DEVIATION REVIEW AND DECISION FORM

Subdivision or Project Name: Saddlehorn Ranch Preliminary Plan

Section of ECM from Which Deviation is Sought: Standard Drawings for Rural Local Roadways
Specific Criteria from Which a Deviation is Sought: ECM criteria for minimum rural local centerline radius

SADDLEHORN RANCH
 200' CL RADIUS VARIANCE
 25142.00
 07/31/19
 SHEET 1 OF 1

RURAL KNUCKLE VARIANCE EXHIBIT

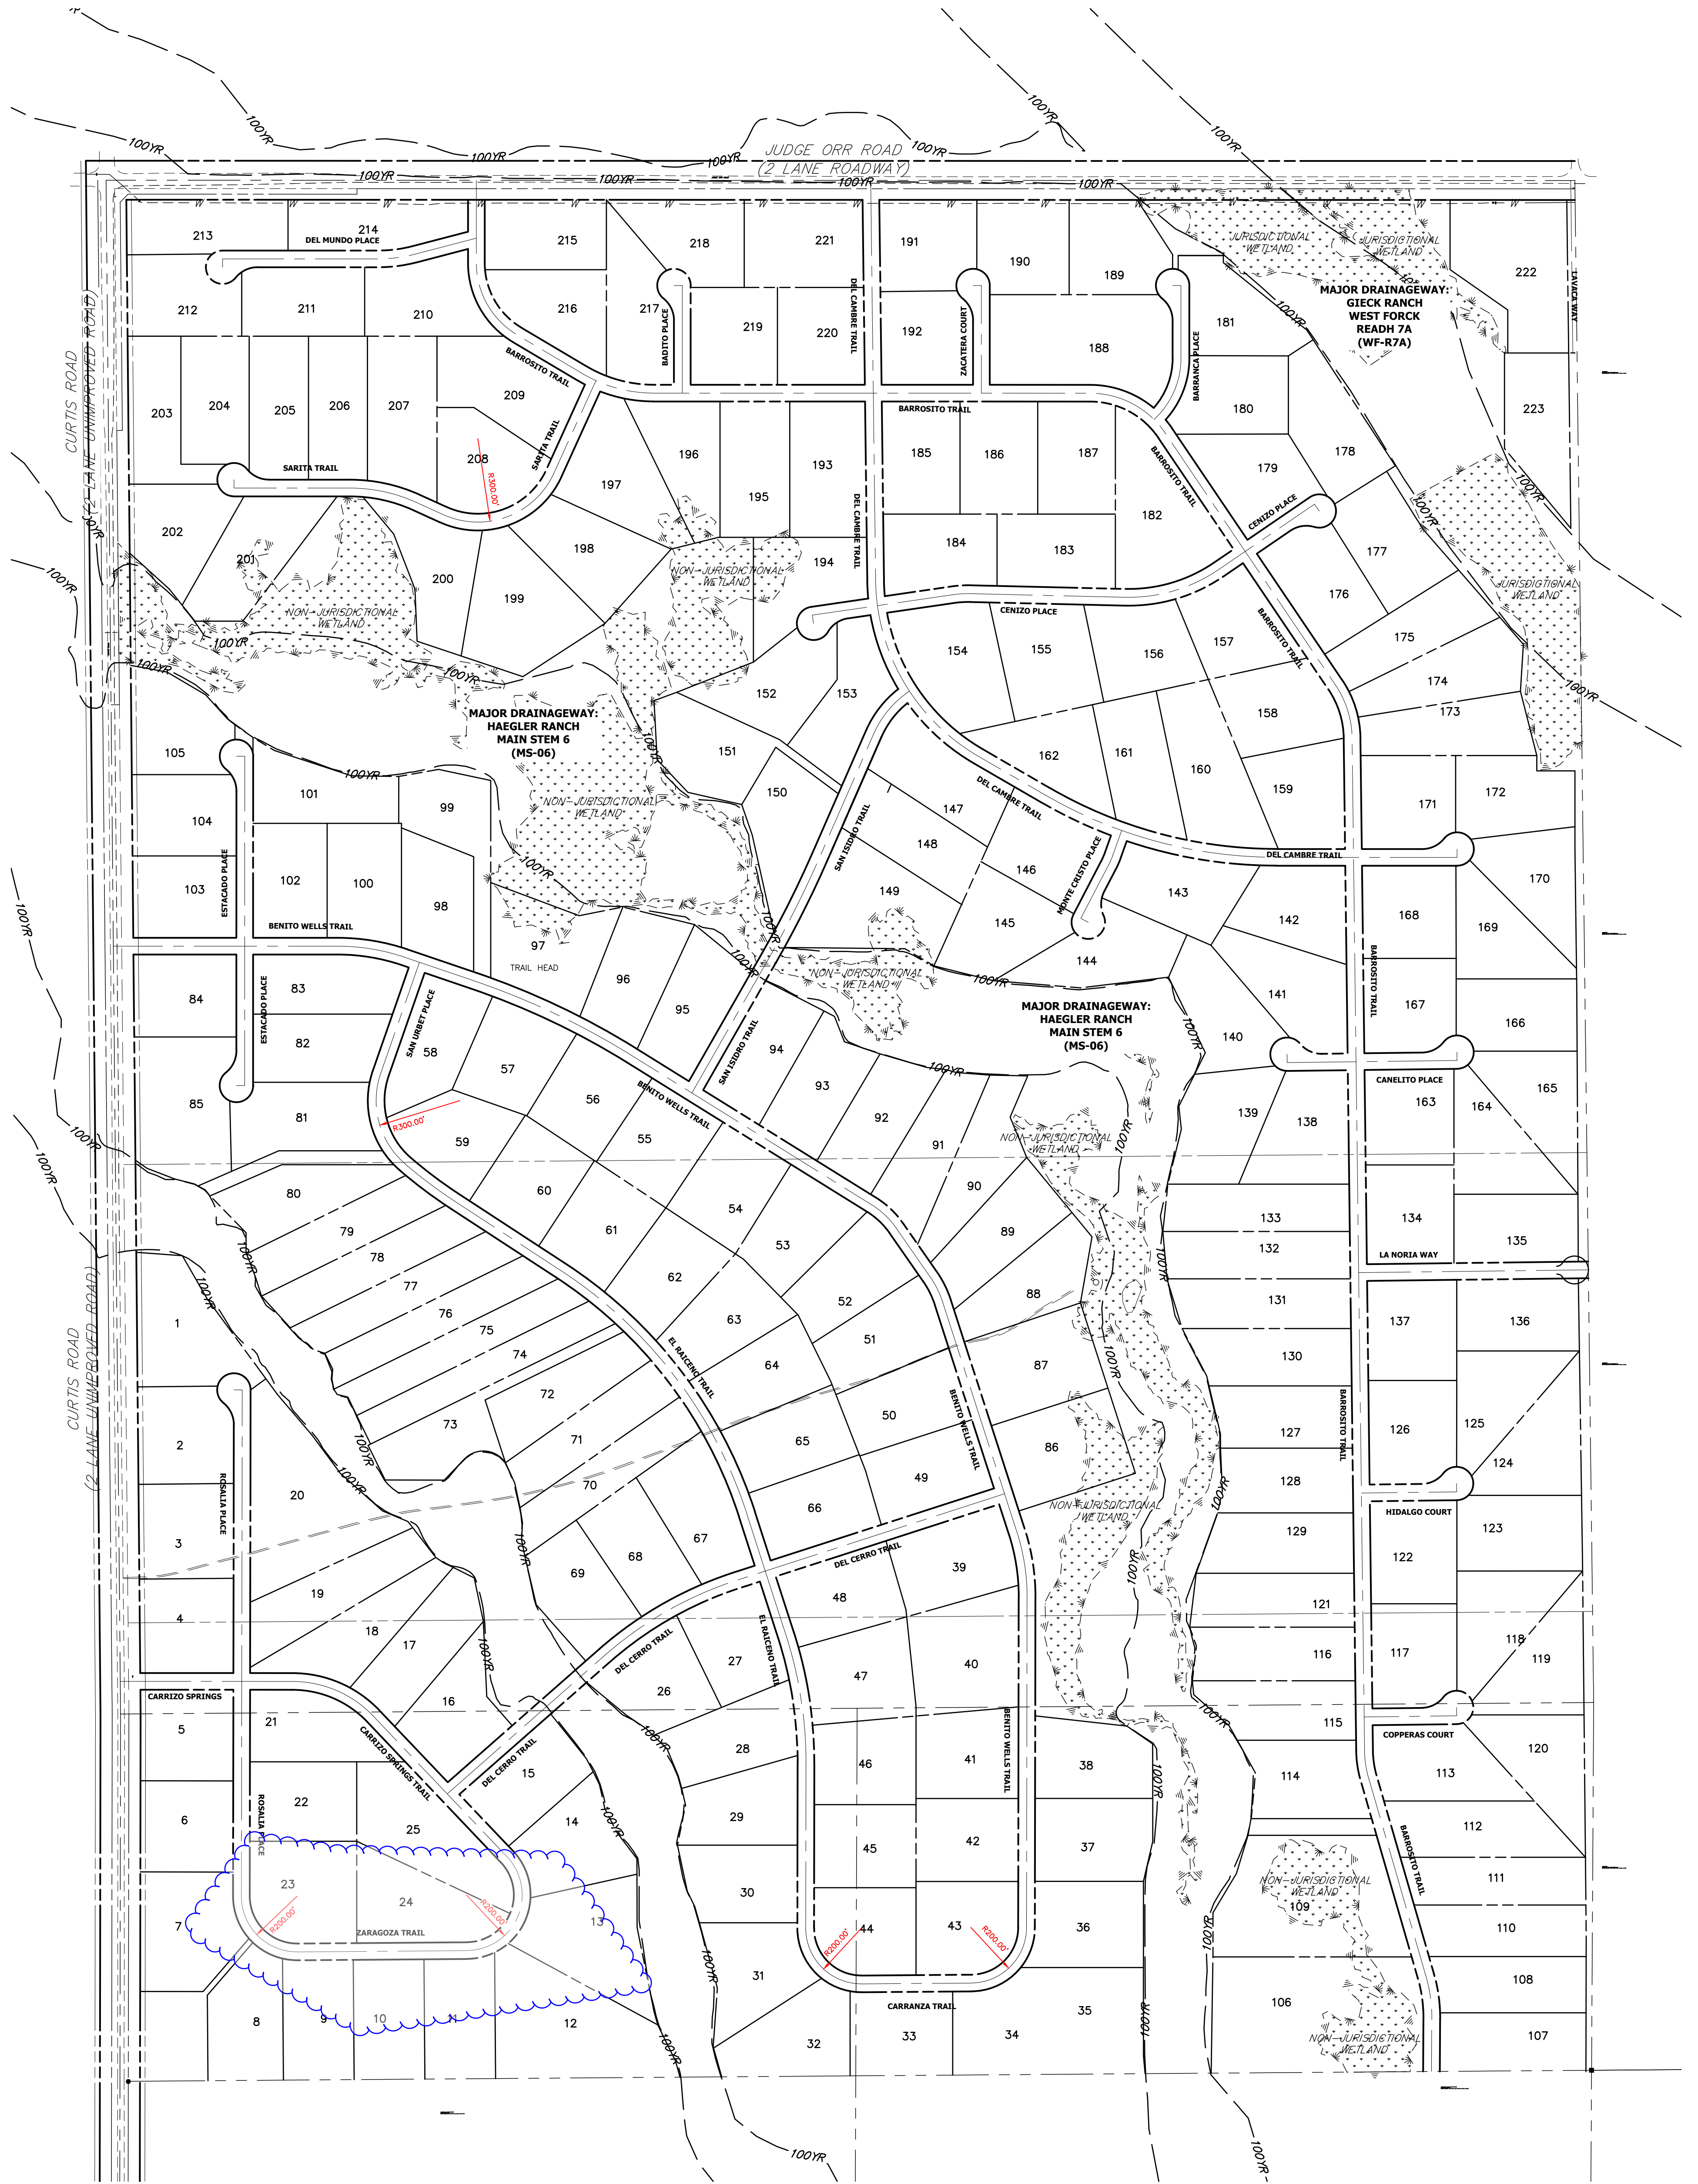
good exhibit, this supports the request on page 2
